Whirl Wind Propellers

SERVICE LETTER

SL-GA-J2B-012714

TO: ALL OWNERS / OPERATORS OF AFFECTED PROPELLERS
SUBJECT: BLADE CLAMP BOLT CRACK
DATE: JANUARY 27, 2014

FIGURE 1 (SL-GA-J2B-012714)

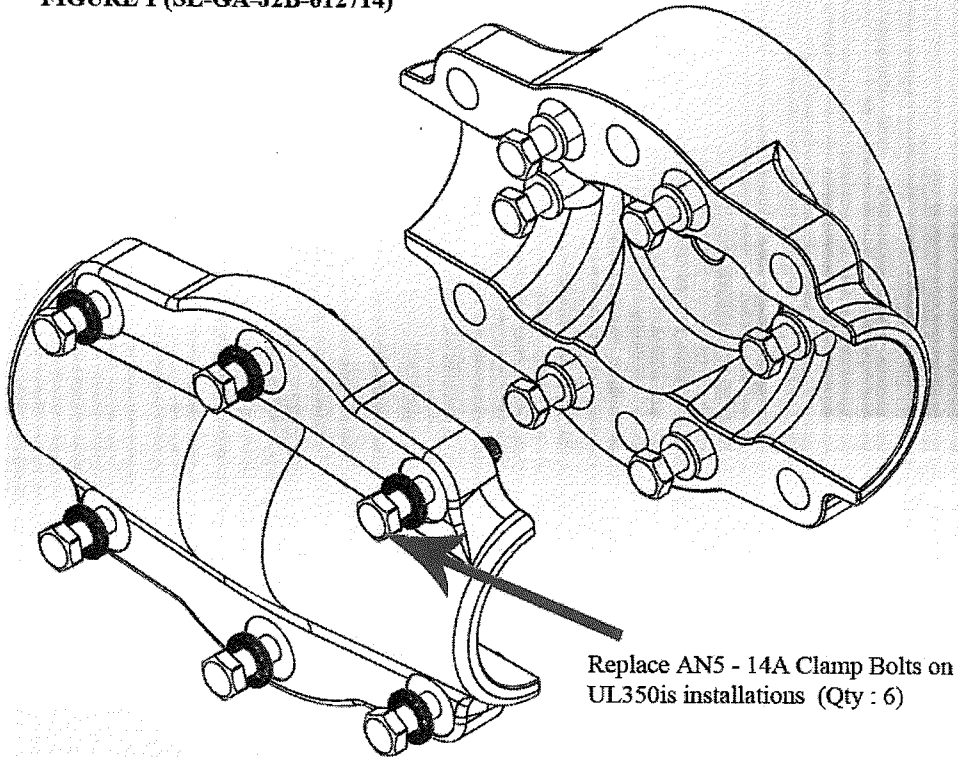
REASON: Upon routine inspection of a **GA-J2B** propeller in the affected Serial Number range, installed on a UL350i engine, one of the propeller blade clamp bolts (AN5-15A) was found to have a crack. The propeller was installed on a UL-350i engine, with 65" diameter blades. The propeller had 300+ hours total time. The bolt crack found so far has been an isolated case.

ACTION: *Reference Figure 1 on Page 2*

Recommend replacement of all 6 hub clamp bolts (AN5-14A for UL350i installations) at time of every annual or every 100 hrs, whichever occurs first.

Affected propellers older than 1 year or with more than 100 hrs: Mandatory replacement of all 6 hub clamp bolts (AN5-14A for UL350i installations) before next flight.
